CHRYSLER 45RFE NEW SOLENOID PACK

CHANGE: A new design Solenoid pack was introduced as a running change in the 2004 model year.

Figure 1

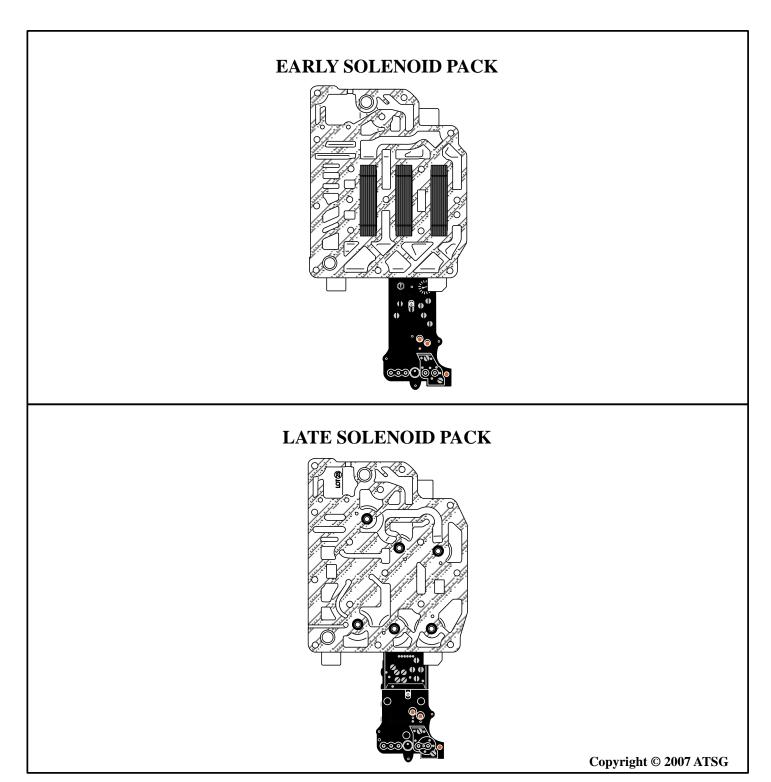
- (1) SOLENOID PACK Totally re-designed casting with changes in the worm track area as shown in Figure 1.
- (2) SOLENOID BODY SCREEN AND GASKET ASSEMBLY Changed to accommodate the changes in the Solenoid Pack and is illustrated in Figure 2.
- (3) TRS/AND 23 WAY CONNECTOR Changed to accommodate internal solenoids. See Figures 3 and 4 for early design and Figures 5 and 6 for updated design.
- (4) RANGE SENSOR SELECTOR PLATE The pocket for the T41 pin was made deeper and is illustrated in Figure 7.

Figure 7

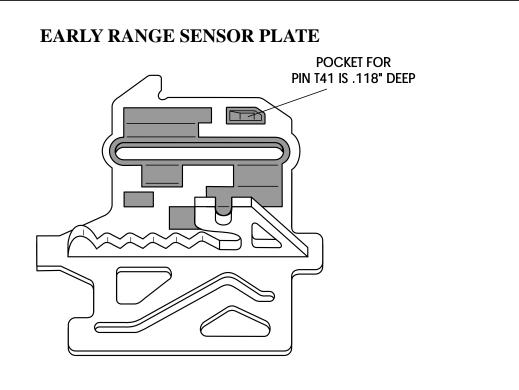
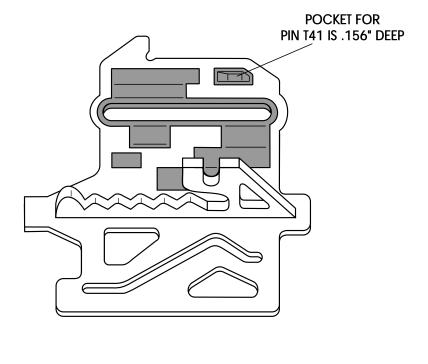
Special Note: The 1999 - 2003 range sensor plate can be modified and used with the updated Solenoid Pack. by making the T41 pocket .040" deeper (Figure 7).
